Agenda
Village of Arlington Heights
Design Commission
Community Room, 3rd Floor

Arlington Heights Village Hall
33 S. Arlington Heights Road
Arlington Heights, IL 60005
June 13, 2017
6:30 PM

MINUTES OF
THE VILLAGE OF ARLINGTON HEIGHTS
DESIGN COMMISSION MEETING
HELD AT THE ARLINGTON HEIGHTS MUNICIPAL BUILDING
33 S. ARLINGTON HEIGHTS RD.
MAY 23, 2017

FRONT ELEVATION
REAR ELEVATION

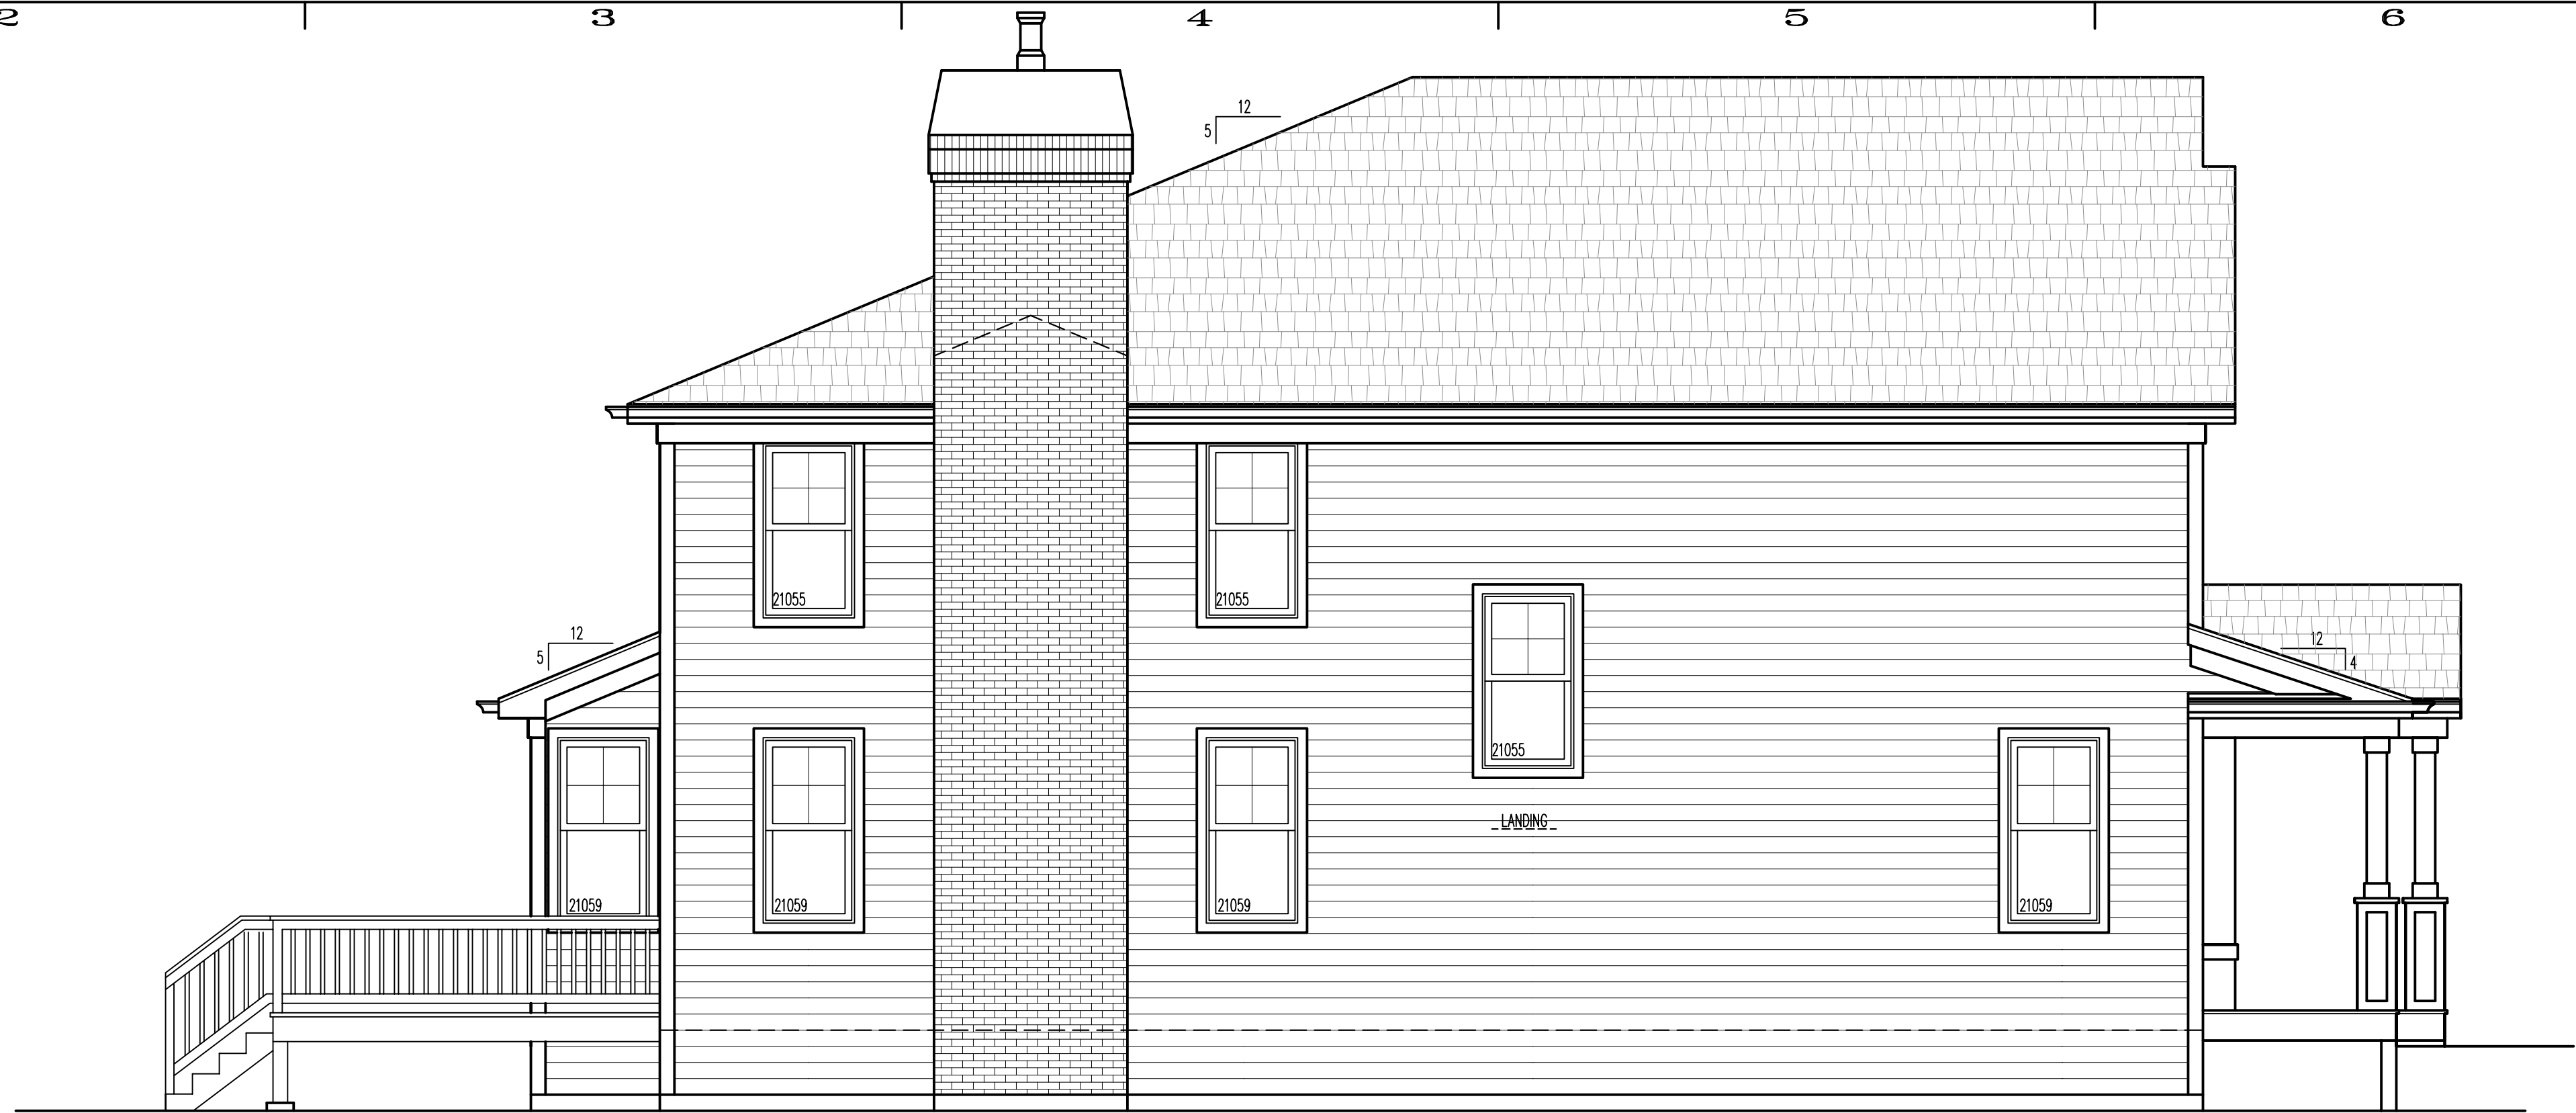
1. **Front Porch.** The proposed front porch only extends across half of the front elevation. For a more authentic appearance, it is recommended that the front porch be extended across the entire front wall of the house. A full front porch will have the added benefit of further screening the attached garage.

1. **Building Height.** Revise the building height to comply with the 25' maximum height.
2. **Front Porch.** Expand the front porch across the entire front of the house.

1C
A201
LEFT ELEVATION

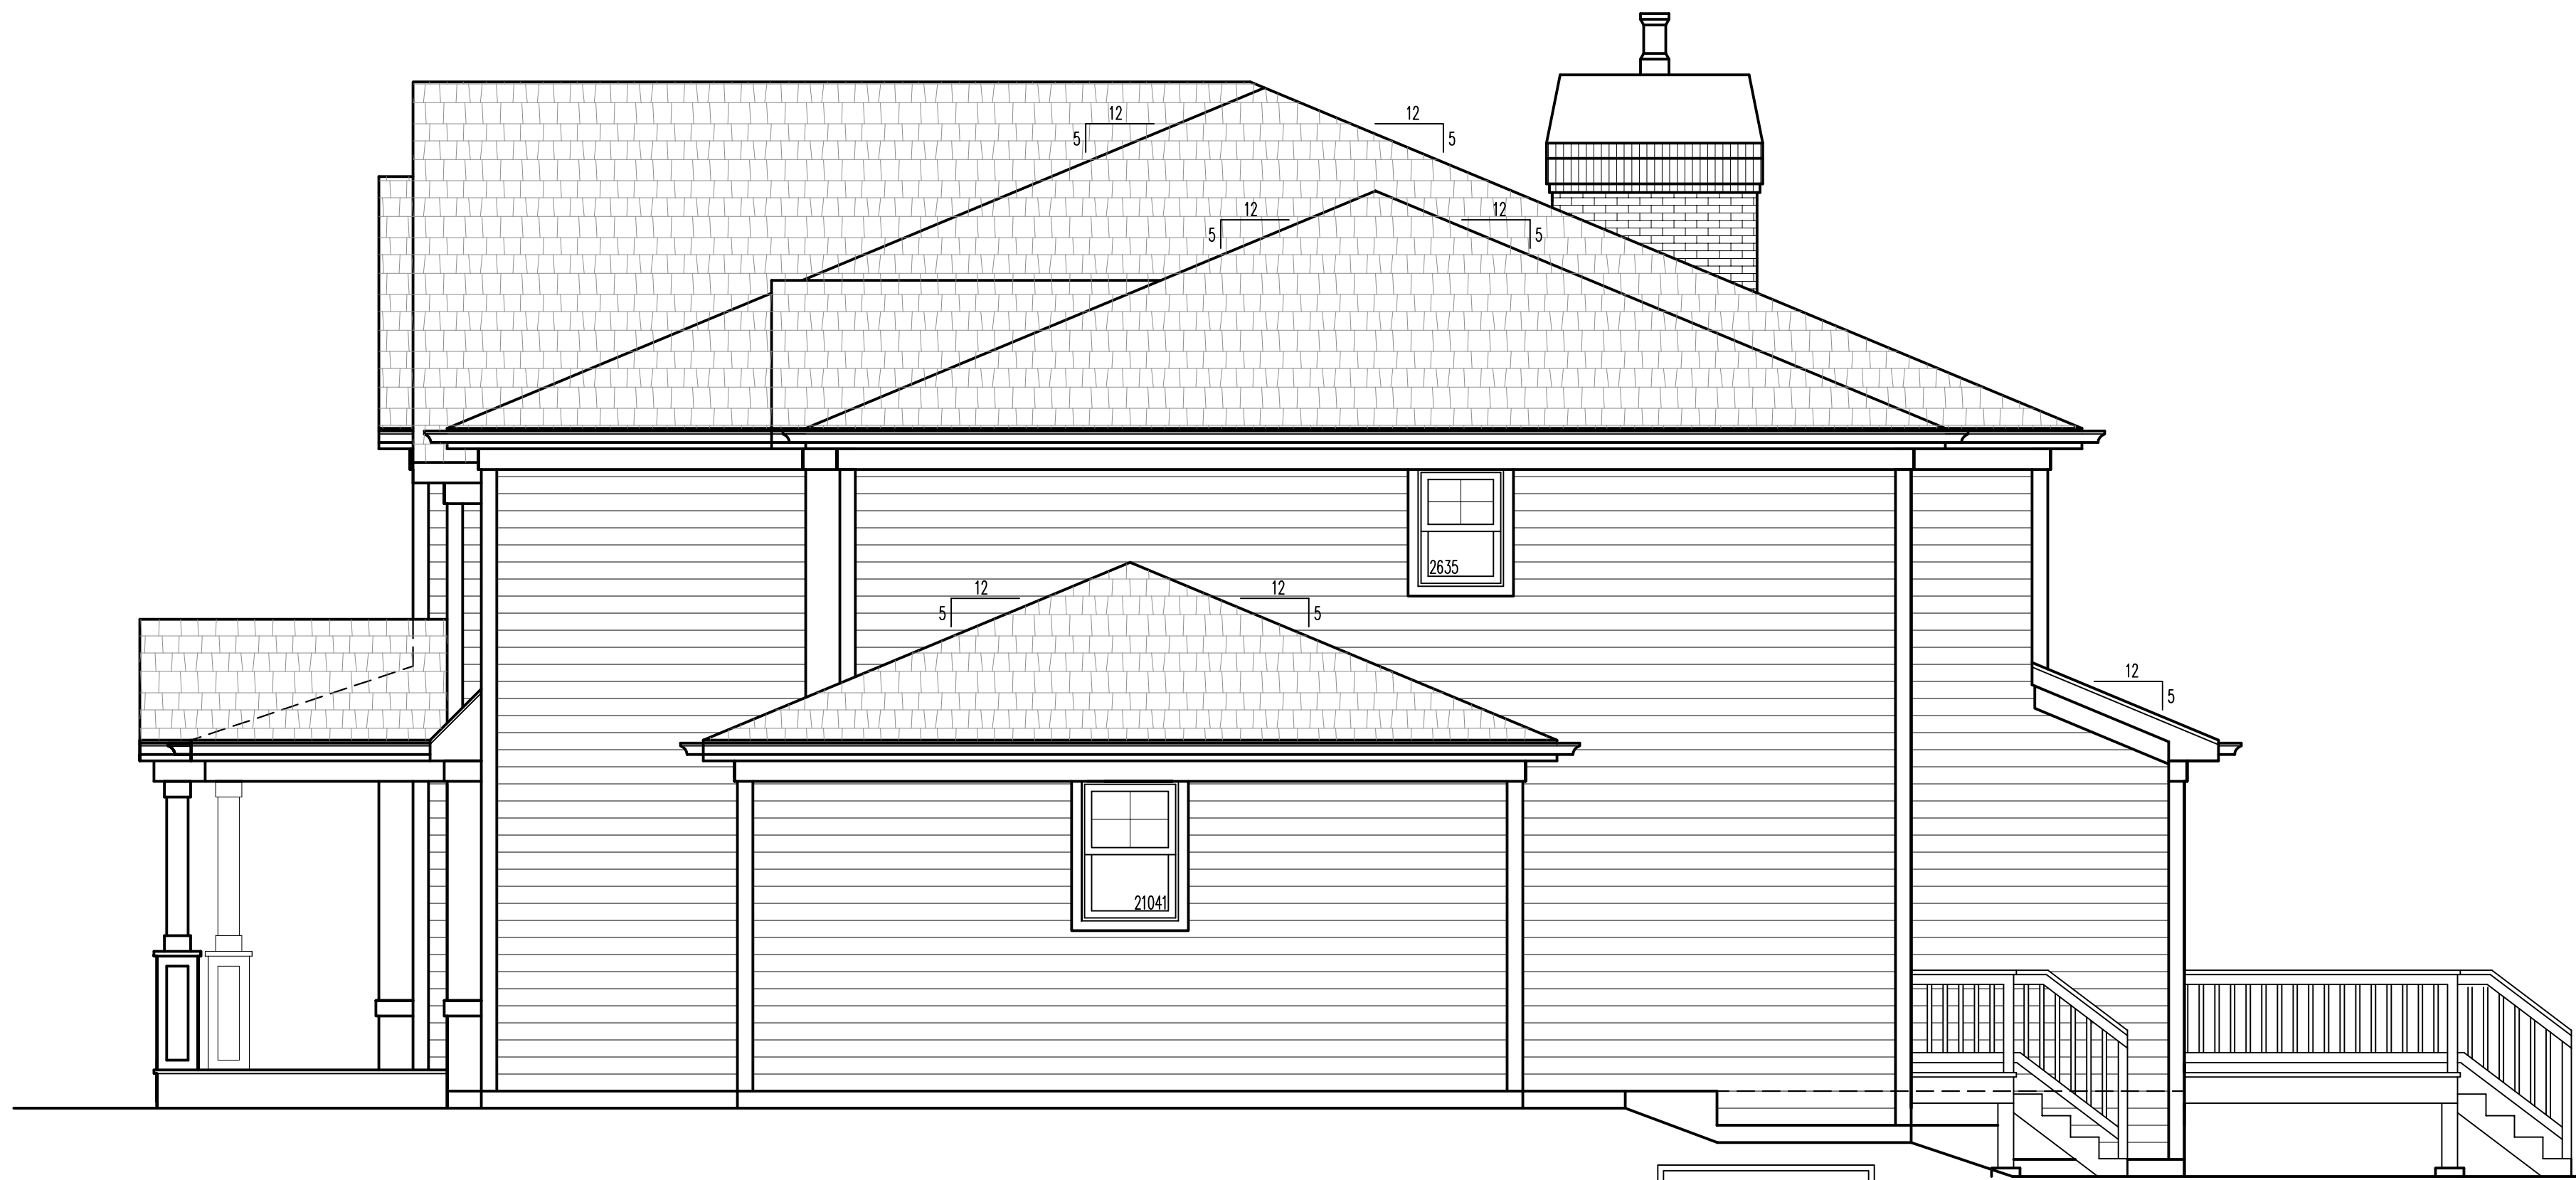
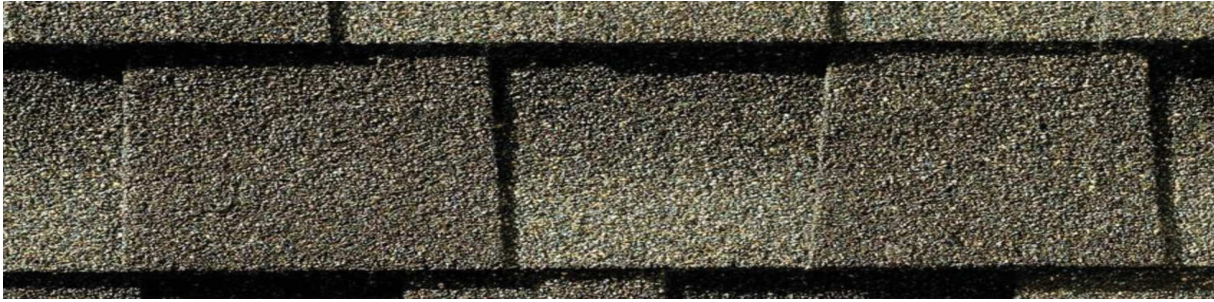
2. **Left Elevation.** The left elevation will be highly visible due to almost 30' of space between the adjacent home to the north. The current elevation lacks character and detail. The following enhancements are recommended:

- a. Add a second window in the Library.
 - b. Provide the 2" and 6" built up window head trim as shown on the front elevation.
 - c. Consider adding a decorative box bay at the stair landing, which could project as much as 7.5 inches if the house were re-centered on the lot.

3. **Left Elevation.** Add a second window in the Library.
4. **Left Elevation.** Provide the 2" and 6" built up window head trim as shown on the front elevation.
